RFB FOR CURRITUCK COMMUNITY PARK PHASE III- BASEBALL/SOFTBALL FIELDS

Date: December 23, 2025

Subject: Addendum No. 1 to RFB for Currituck Community Park Phase III- Baseball/Softball Fields

7 **BLACK VINYL COATED FENCE BACKSTOP**
N.T.S.

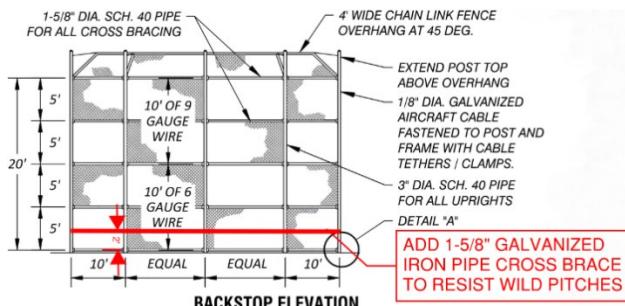
4. Backstop fencing is to be better supported approximately 2' above the bottom rails by addition of a cross-brace per this detail modification—
